S4.55 LIST OF AMENDMENTS:

PROJECT  
THREE STOREY RESIDENTIAL FLAT BUILDING WITH BASEMENT CAR PARK AT:  
5 COMMONWEALTH PDE, MANLY, NSW  
CLIENT  
C.G. & I.B. KOUTSOS

DRAWING TITLE	STATUS	NUMBER	REVISION
GROUND FLOOR PLAN	S4.55	A1.01	s4.55
SCALE	STATUS	NUMBER	REVISION
1:100 @A3	S4.55	A1.01	s4.55

DRAWING TITLE  
**EXTERNAL WORKS PLAN**

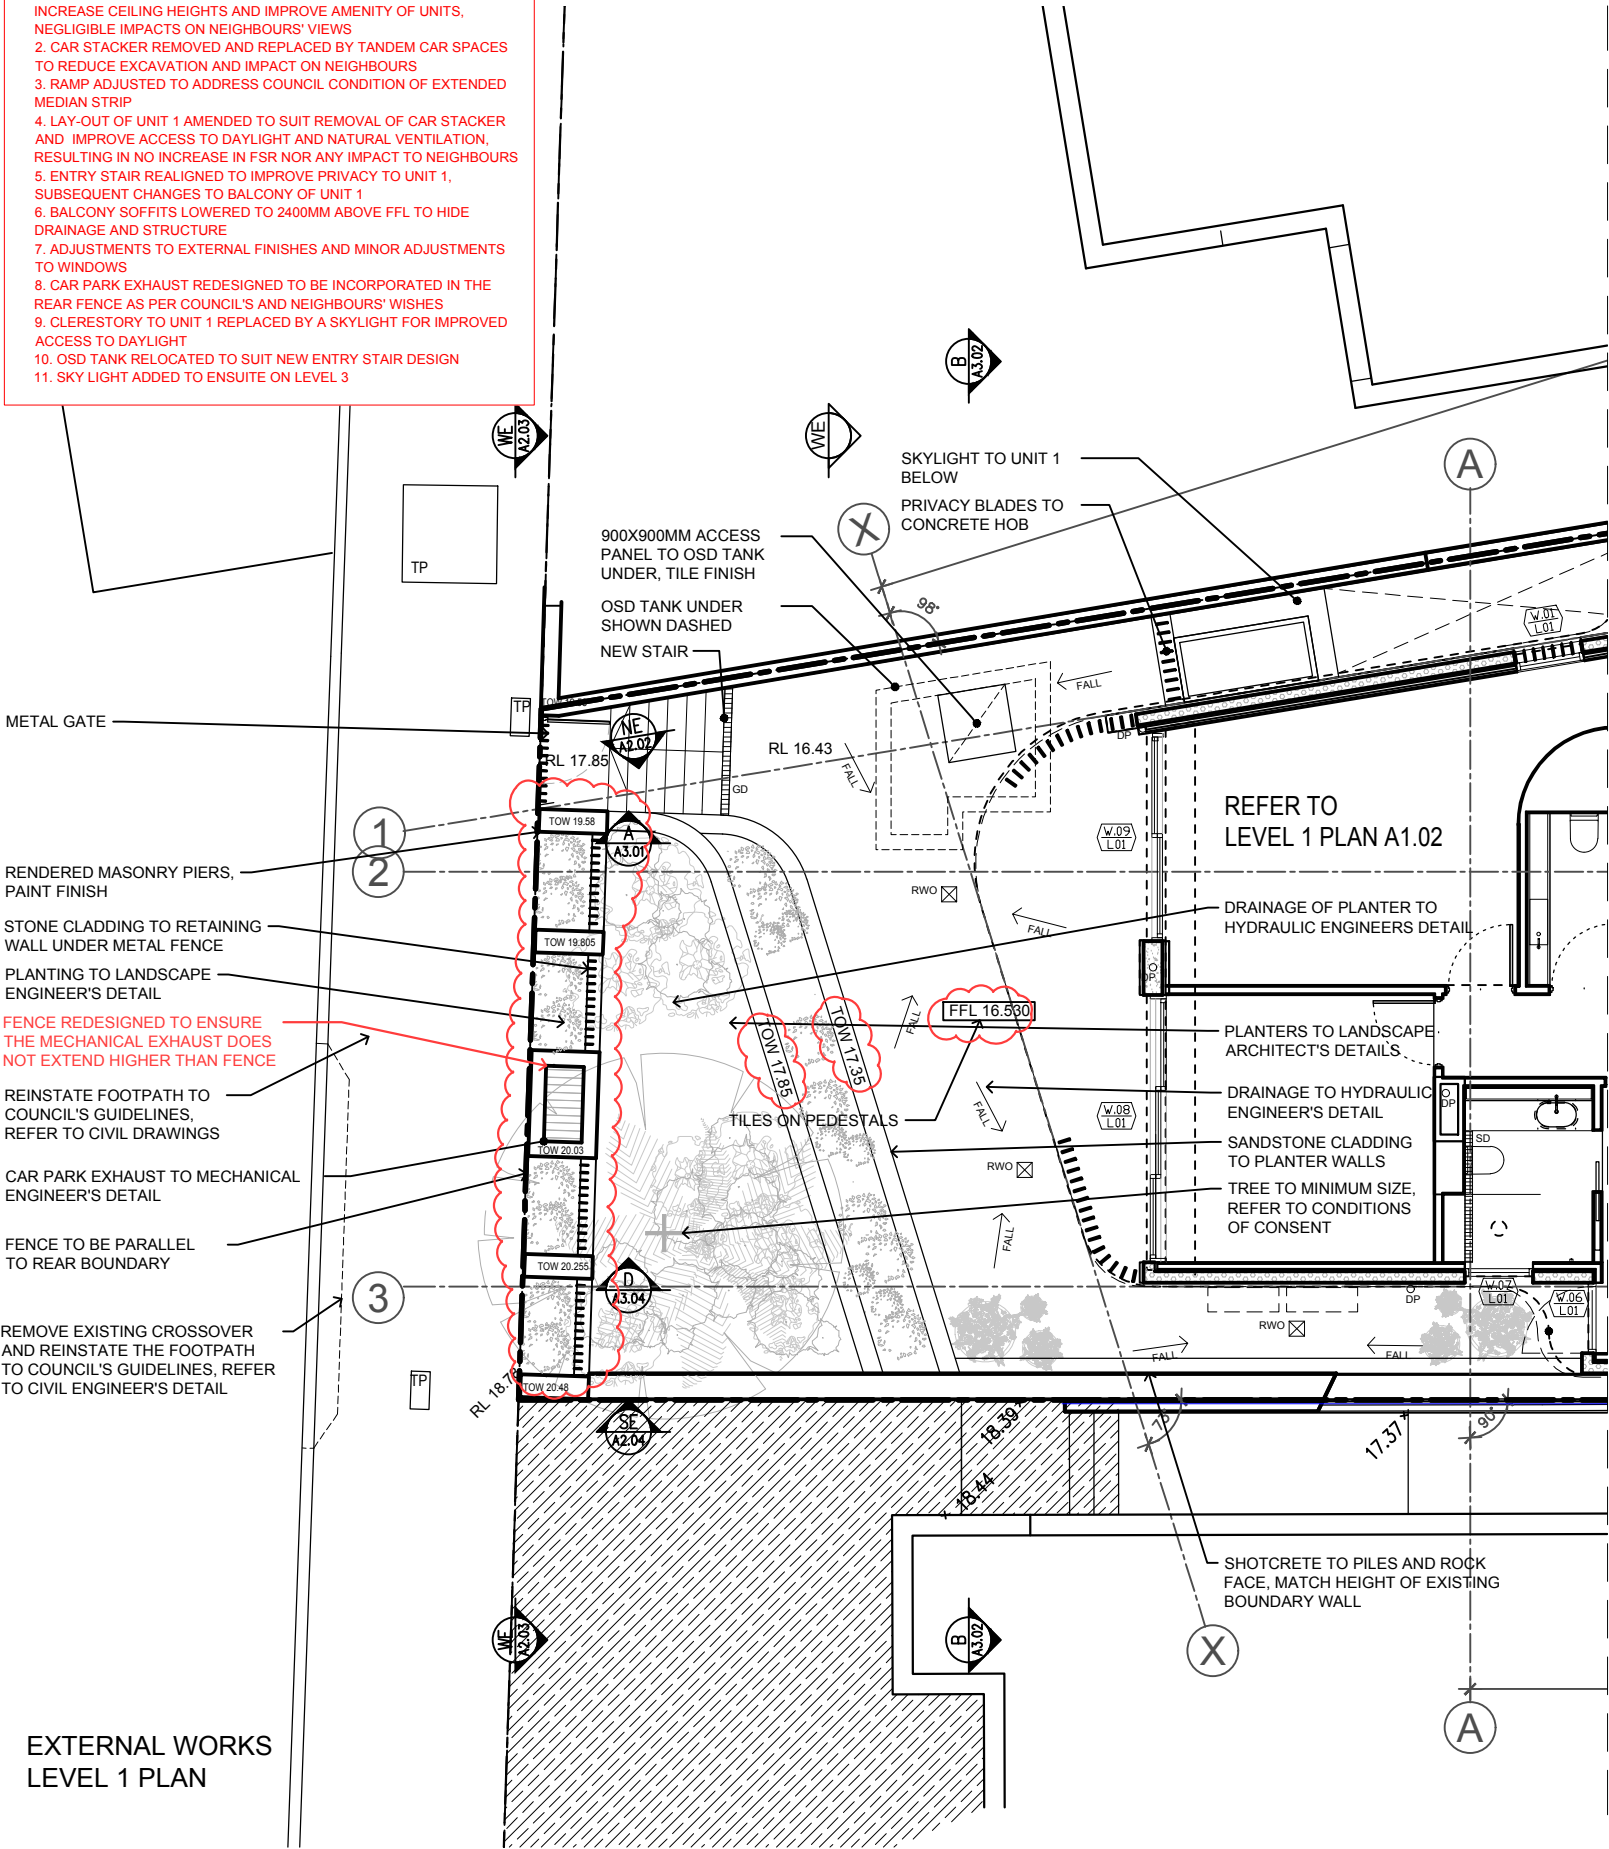
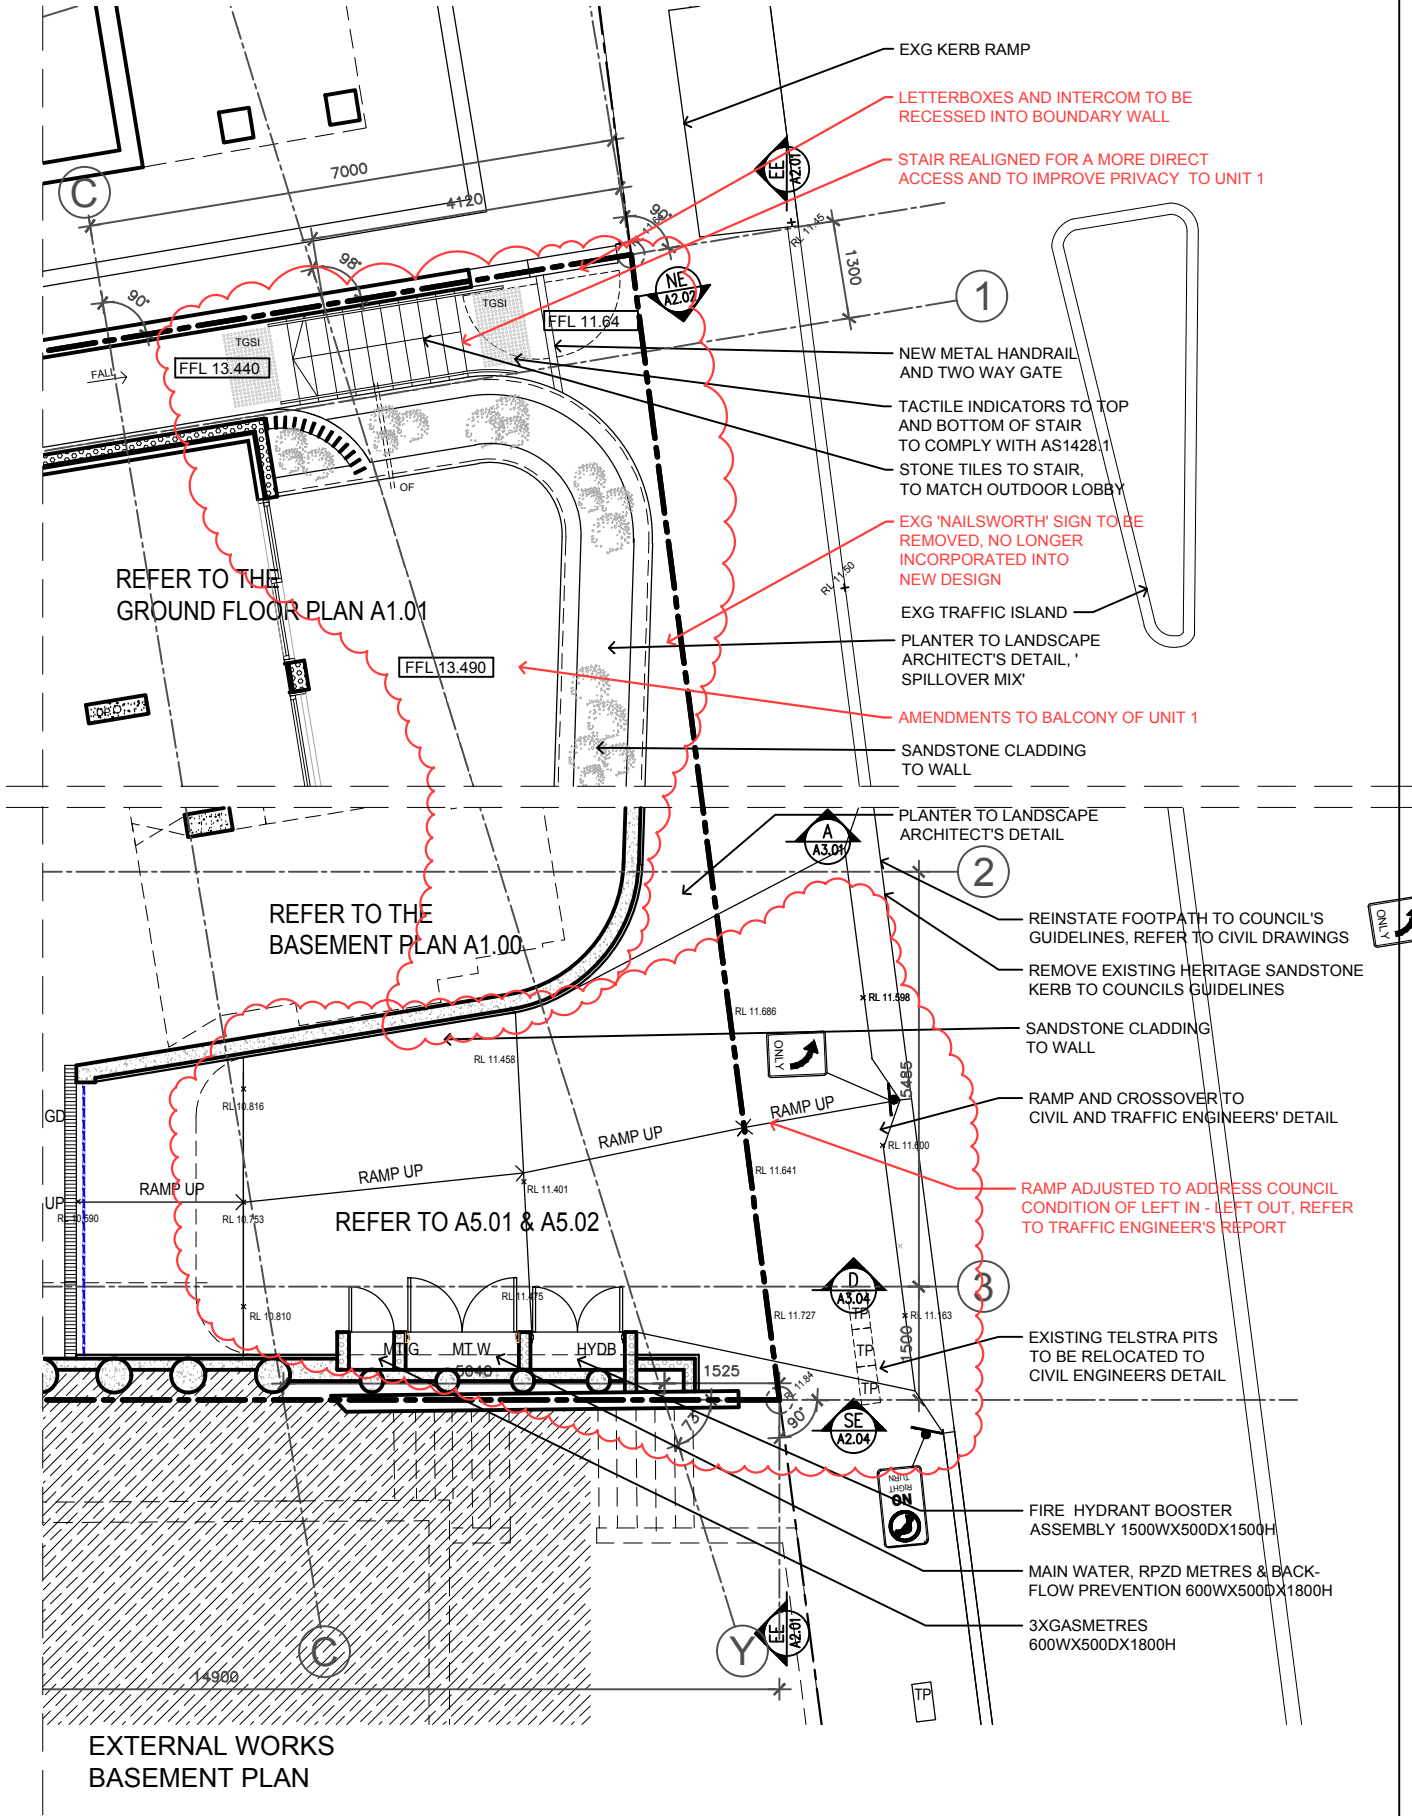
1. BUILDING RAISED 170MM TO ALIGN WITH EXISTING RIDGE LEVEL TO INCREASE CEILING HEIGHTS AND IMPROVE AMENITY OF UNITS, NEGLIGIBLE IMPACTS ON NEIGHBOURS' VIEWS

2. CAR STACKER REMOVED AND REPLACED BY TANDEM CAR SPACES TO REDUCE EXCAVATION AND IMPACT ON NEIGHBOURS
3. RAMP ADJUSTED TO ADDRESS COUNCIL CONDITION OF EXTENDED MEDIAN STRIP

4. LAY-OUT OF UNIT 1 AMENDED TO SUIT REMOVAL OF CAR STACKER AND IMPROVE ACCESS TO DAYLIGHT AND NATURAL VENTILATION, RESULTING IN NO INCREASE IN FSR NOR ANY IMPACT TO NEIGHBOURS

5. ENTRY STAIR REALIGNED TO IMPROVE PRIVACY TO UNIT 1, SUBSEQUENT CHANGES TO BALCONY OF UNIT 1
6. BALCONY SOFFITS LOWERED TO 2400MM ABOVE FFL TO HIDE DRAINAGE AND STRUCTURE

7. ADJUSTMENTS TO EXTERNAL FINISHES AND MINOR ADJUSTMENTS TO WINDOWS
8. CAR PARK EXHAUST REDESIGNED TO BE INCORPORATED IN THE REAR FENCE AS PER COUNCIL'S AND NEIGHBOURS' WISHES

9. CLERESTORY TO UNIT 1 REPLACED BY A SKYLIGHT FOR IMPROVED ACCESS TO DAYLIGHT
10. OSD TANK RELOCATED TO SUIT NEW ENTRY STAIR DESIGN
11. SKY LIGHT ADDED TO ENSUITE ON LEVEL 3

DRAWING TITLE  
**EAST ELEVATION**  
SCALE  
1:100  
@A3  
STATUS  
**S4.55**

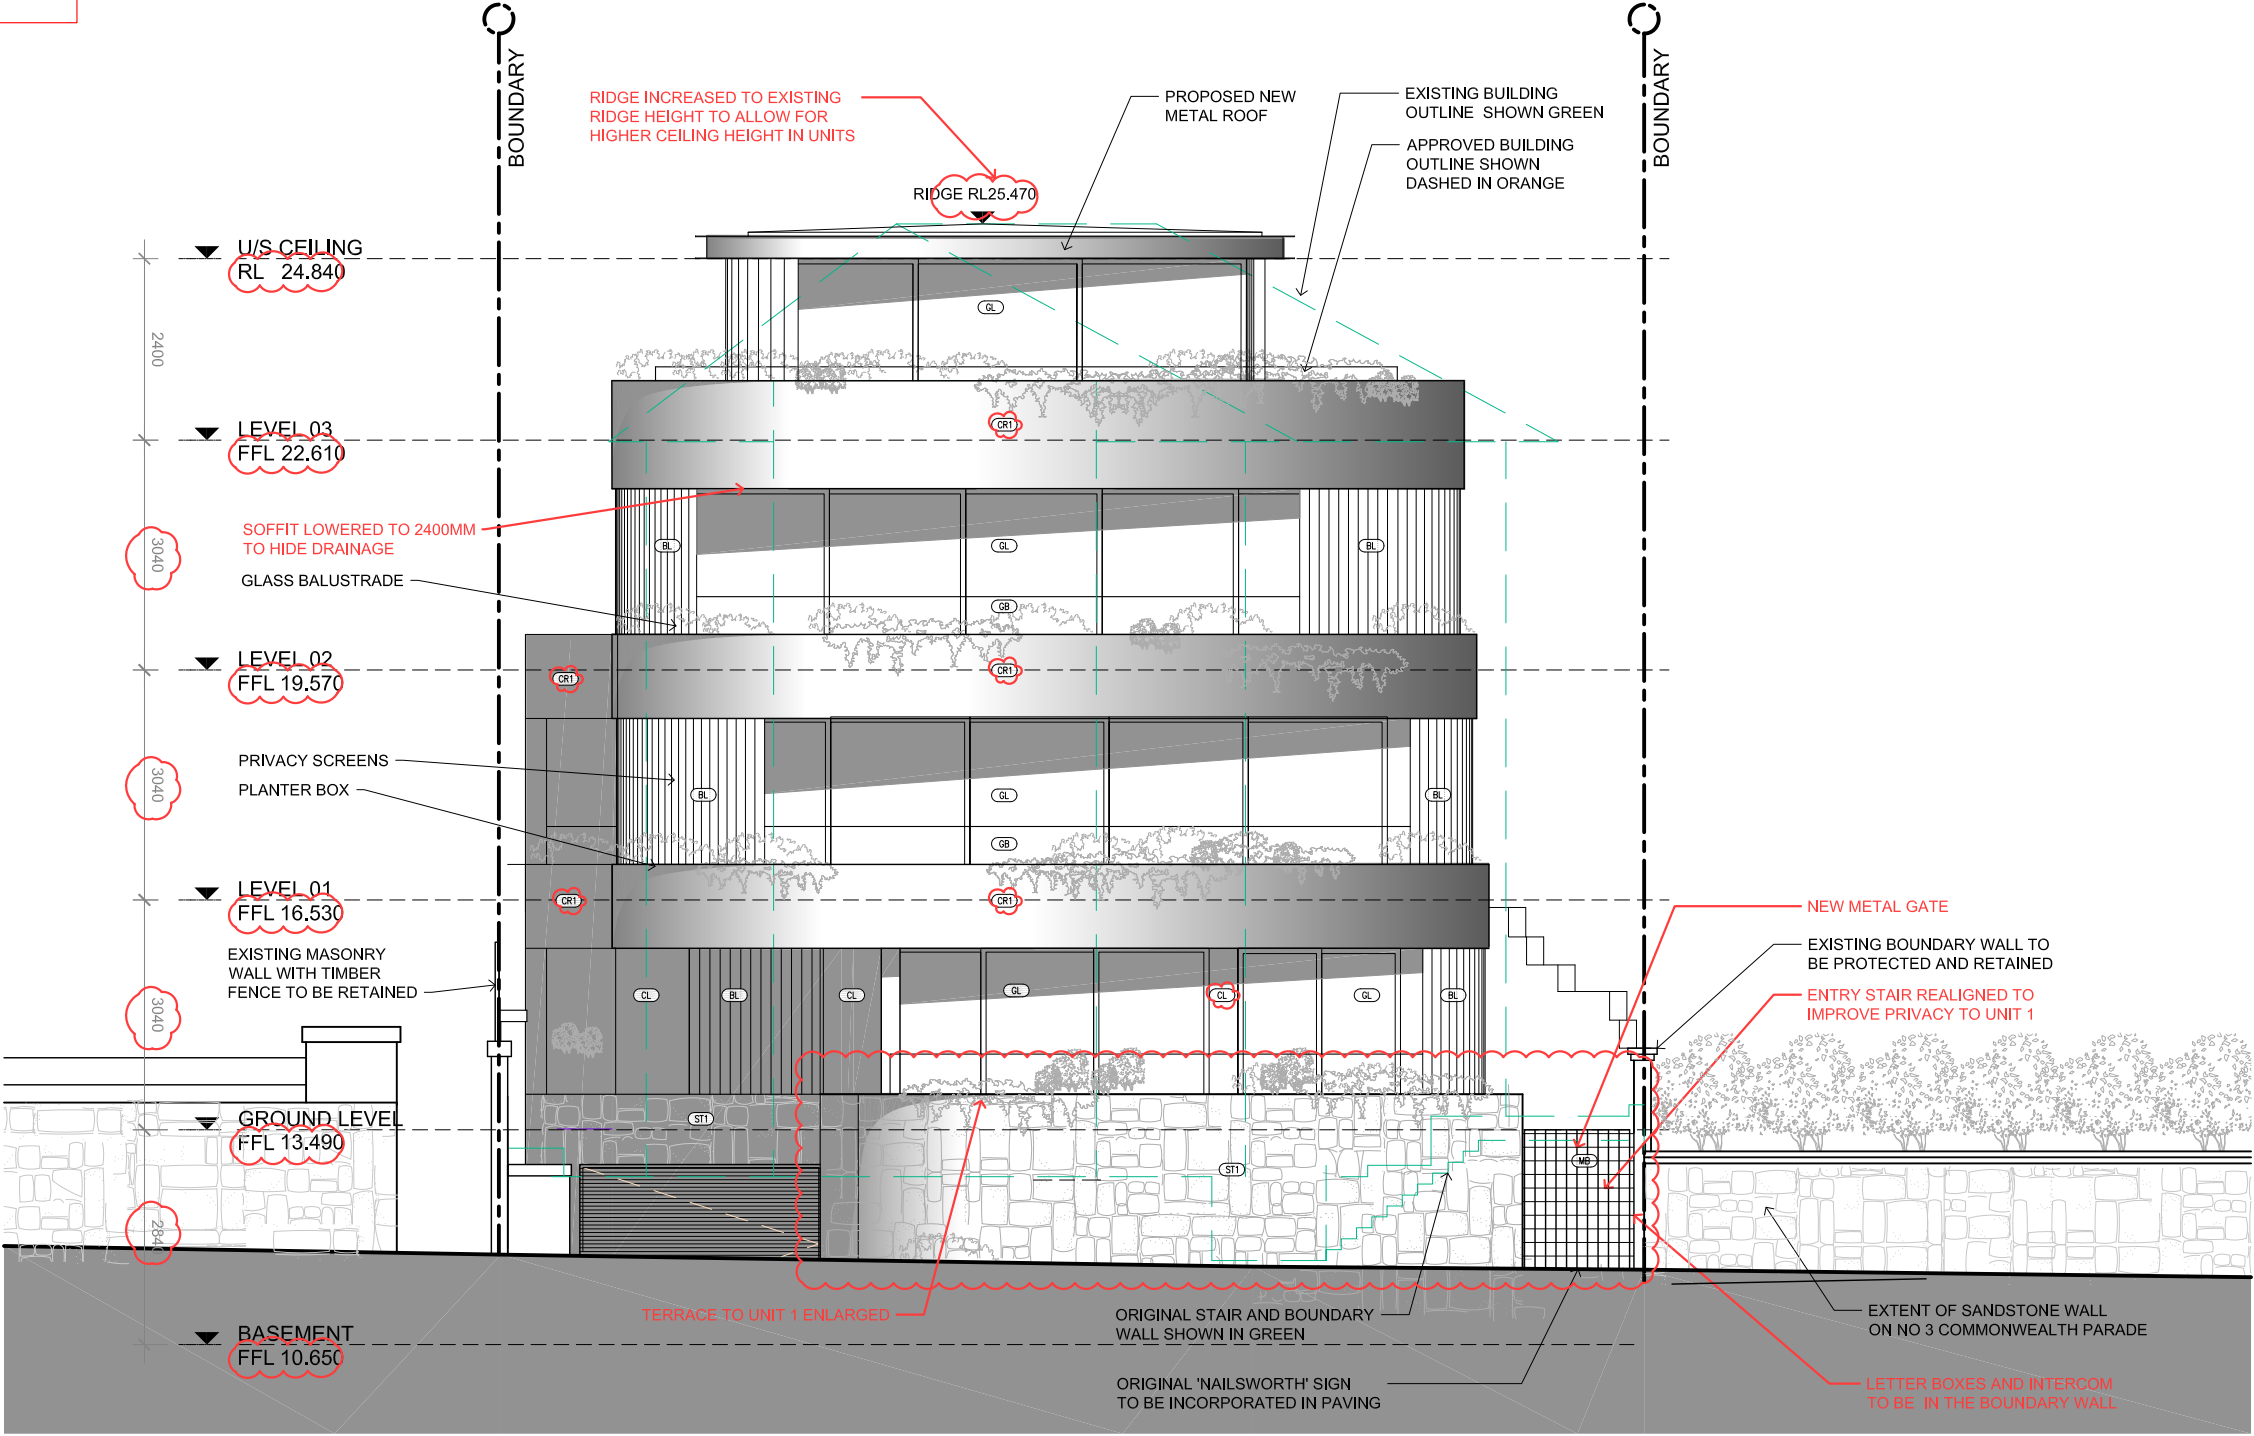
1. BUILDING RAISED 170MM TO ALIGN WITH EXISTING RIDGE LEVEL TO INCREASE CEILING HEIGHTS AND IMPROVE AMENITY OF UNITS, NEGLIGIBLE IMPACTS ON NEIGHBOURS' VIEWS

2. CAR STACKER REMOVED AND REPLACED BY TANDEM CAR SPACES TO REDUCE EXCAVATION AND IMPACT ON NEIGHBOURS
3. RAMP ADJUSTED TO ADDRESS COUNCIL CONDITION OF EXTENDED MEDIAN STRIP

4. LAY-OUT OF UNIT 1 AMENDED TO SUIT REMOVAL OF CAR STACKER AND IMPROVE ACCESS TO DAYLIGHT AND NATURAL VENTILATION, RESULTING IN NO INCREASE IN FSR NOR ANY IMPACT TO NEIGHBOURS

5. ENTRY STAIR REALIGNED TO IMPROVE PRIVACY TO UNIT 1, SUBSEQUENT CHANGES TO BALCONY OF UNIT 1
6. BALCONY SOFFITS LOWERED TO 2400MM ABOVE FFL TO HIDE DRAINAGE AND STRUCTURE

7. ADJUSTMENTS TO EXTERNAL FINISHES AND MINOR ADJUSTMENTS TO WINDOWS
8. CAR PARK EXHAUST REDESIGNED TO BE INCORPORATED IN THE REAR FENCE AS PER COUNCIL'S AND NEIGHBOURS' WISHES

9. CLERESTORY TO UNIT 1 REPLACED BY A SKYLIGHT FOR IMPROVED ACCESS TO DAYLIGHT
10. OSD TANK RELOCATED TO SUIT NEW ENTRY STAIR DESIGN
11. SKY LIGHT ADDED TO ENSUITE ON LEVEL 3
